UNITED STATES
NUCLEAR REGULATORY COMMISSION
WASHINGTON, D.C. 20555-0001

February 16, 2017

SUBJECT: DRESDEN NUCLEAR POWER STATION, UNITS 2 AND 3 – SAFETY EVALUATION REGARDING IMPLEMENTATION OF MITIGATING STRATEGIES AND RELIABLE SPENT FUEL POOL INSTRUMENTATION RELATED TO ORDERS EA-12-049 AND EA-12-051 (CAC NOS. MF1046, MF1047, MF1050, AND MF1051)

Figure 1 - “Dresden SFP Levels of Monitoring”

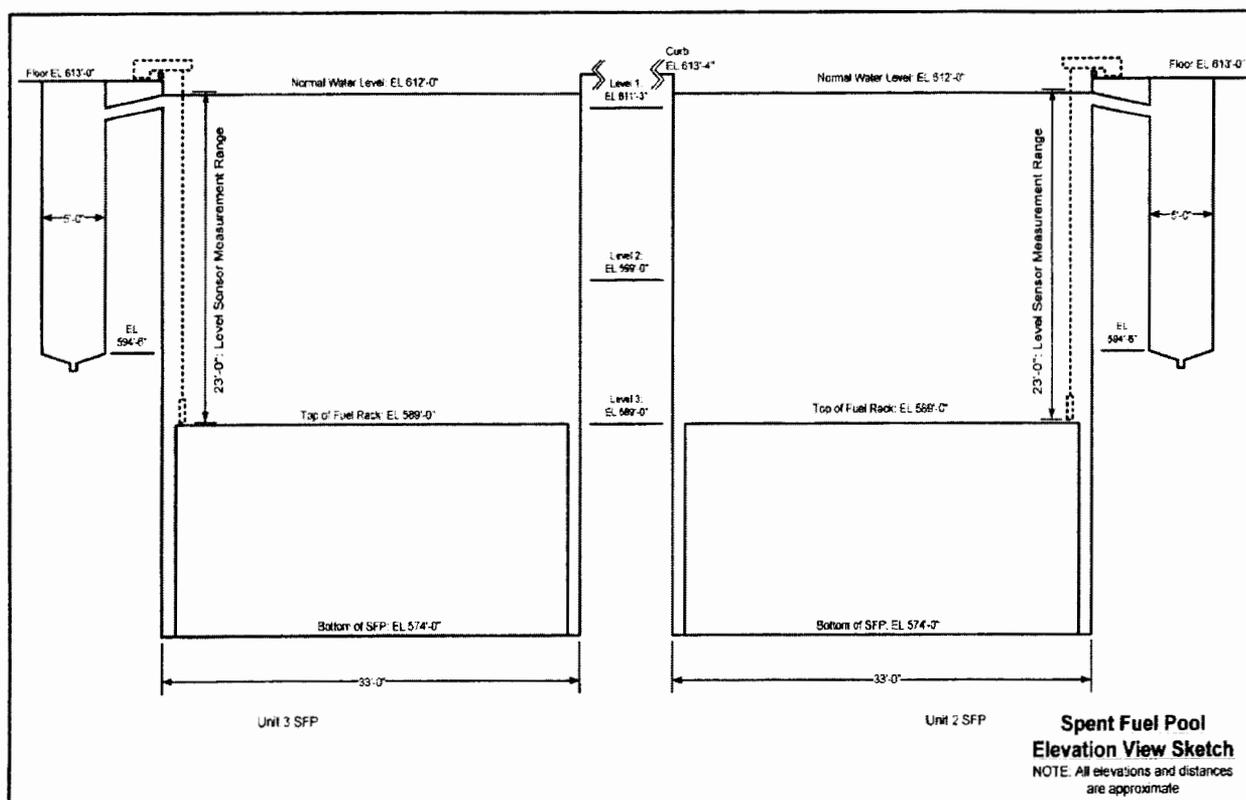
In its letter dated July 18, 2013 [Reference 26], the licensee provided a sketch depicting the final SFP levels of monitoring and the instrument's measurement range (Figure 1 of this evaluation). In this figure, the measurement range is from 612' 0" to 589' 0" plant elevation. The NRC staff noted that the measurement range will cover Levels 1, 2, and 3, as described in Section 4.1 above.
